Amendment 78 to  
DPR-16

SUBJECT: ADMINISTRATIVE CONTROLS

Re: Oyster Creek Nuclear Generating Station

SAFETY EVALUATION BY THE OFFICE OF NUCLEAR REACTOR REGULATION  
SUPPORTING AMENDMENT NO. 78 TO PROVISIONAL OPERATING LICENSE NO. DPR-16

**FIGURE 6.22**  
**ONSITE ORGANIZATION**

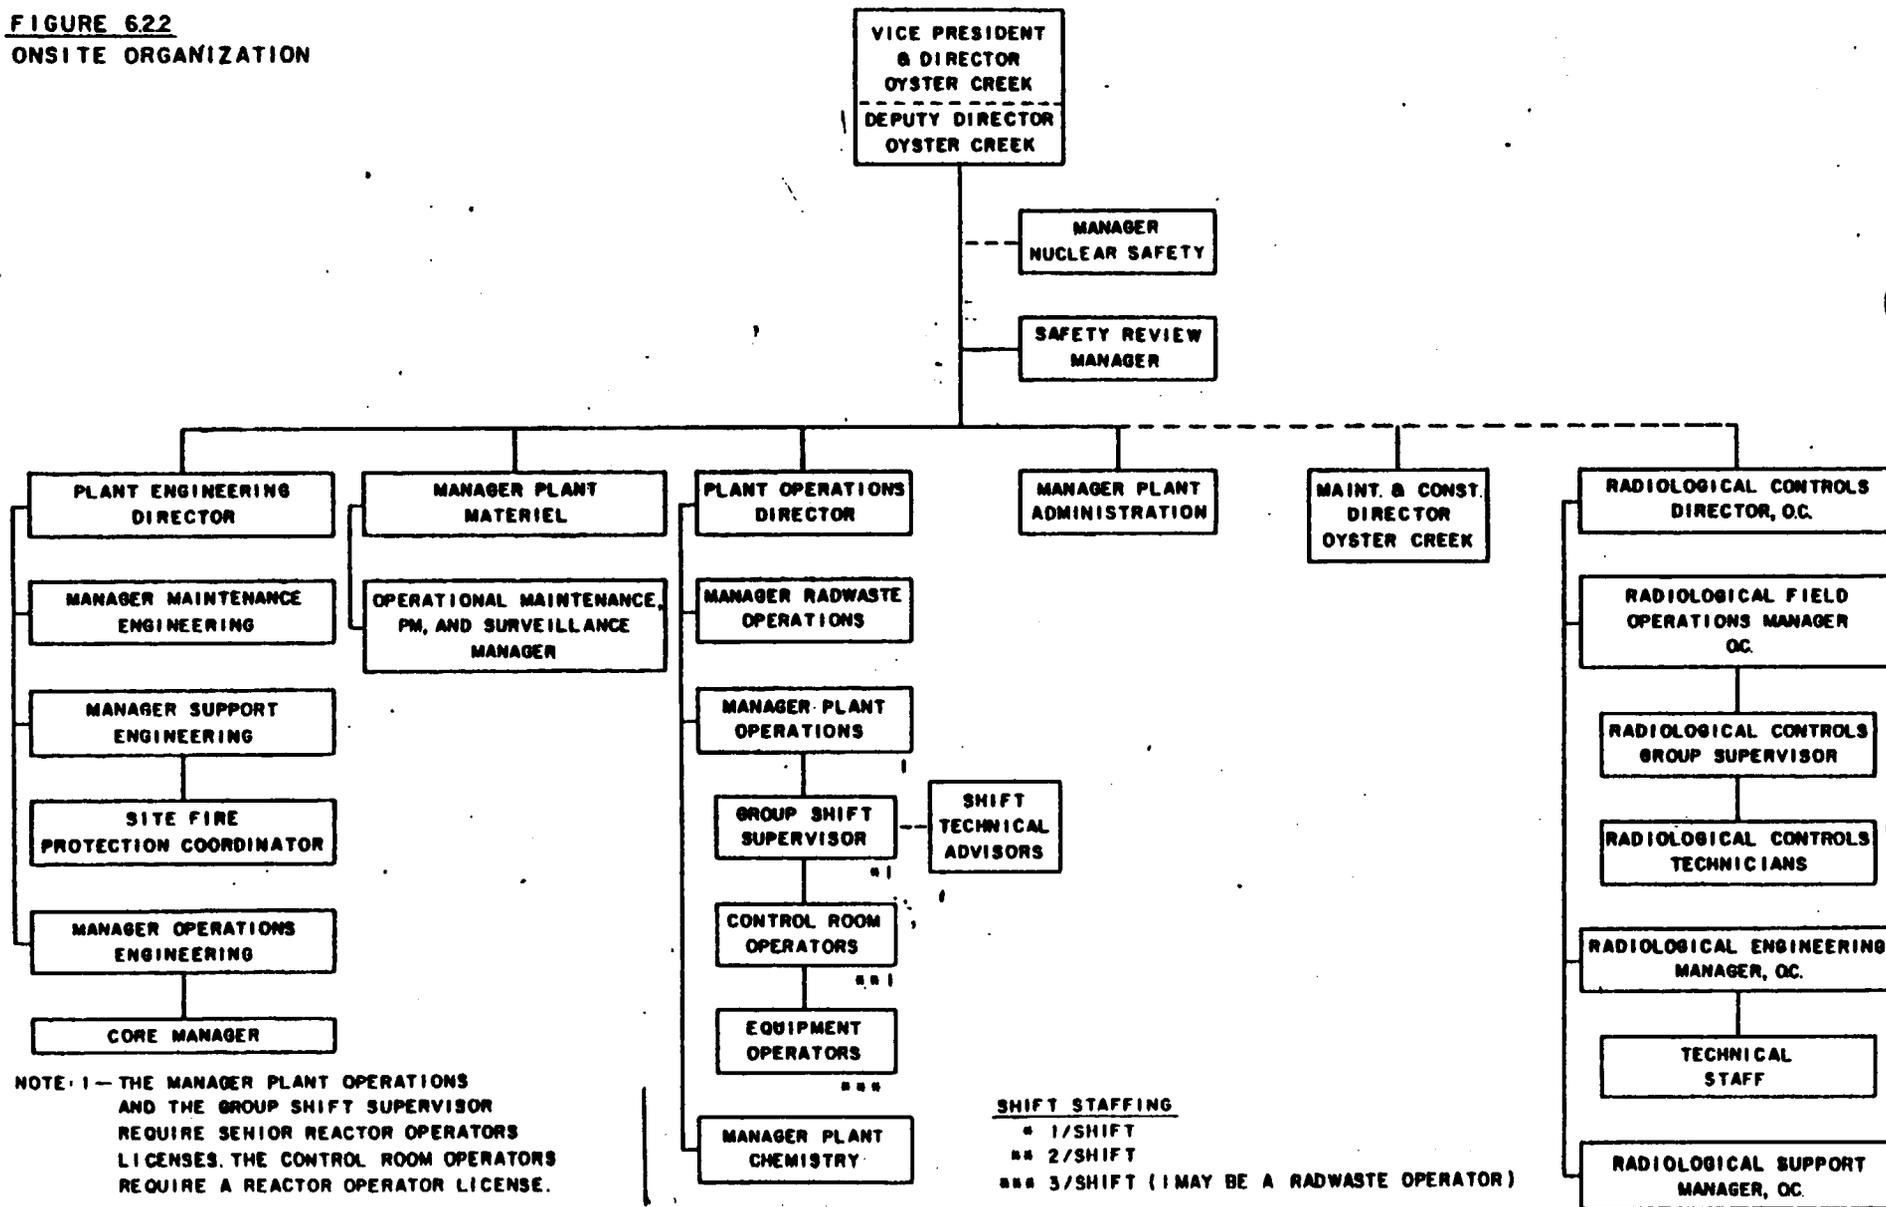
The Plant Engineering organization will be restructured as depicted in revised Figure 6.2.2 and as described in revised Section 6.3.1. The responsibilities of the Manager-Plant Engineering will be split into three separate areas: Operations Engineering, Maintenance Engineering and Support Engineering. Each of the three areas will be headed by a Manager

The Fire Protection Supervisor title will be revised to Site Fire Protection Coordinator since this position no longer directly supervises the activities of fire protection personnel. This position reports to the Manager-Support Engineering, but continues direct access to the Plant Engineering Director providing an additional level of technical support to this function. Since the technical responsibilities of the position remain the same, the staff finds this proposed administrative change acceptable.

The title of Manager-Core Engineering will be revised to Core Manager. This position reports directly to the Manager-Operations Engineering and relieves this position of some administrative responsibilities which allows more time for technical duties. An additional level of expertise is also provided to the Plant Engineering Director. The description of the Core Manager has been placed in a new place on TS page 6-6 because the position now ranks at a different level in the facility staff organization. Since the technical responsibilities of this position remain as specified in Section 6.3, the staff finds this proposed administrative change acceptable.

The position of Chemistry Manager no longer falls under the cognizance of the Plant Engineering organization. This position now reports to the Plant Operations Director and is subsequently deleted from Plant Engineering; this title has also been changed to Manager-Plant Chemistry. The description of the Manager-Plant Chemistry has been moved from the bottom of TS page 6-6 to the bottom of TS page 6-5 because the position now ranks at a higher level in the facility staff organization. Since the qualifications of this position remain the same and the position's reporting requirements have not been downgraded, the staff finds this administrative change acceptable.

Another change to the onsite organization at Oyster Creek is that the position of Manager/Deputy Radiological Controls has been upgraded to the Director level. The title of the position will be revised from Manager/Deputy Radiological Controls to Radiological Controls Director. This revision in titles will also be made in TS Section 6.3.2 which has a reference to the Manager/Deputy Radiological Controls. The TS requirements and reporting requirements remain the same for this position; therefore the staff finds these administrative changes acceptable.
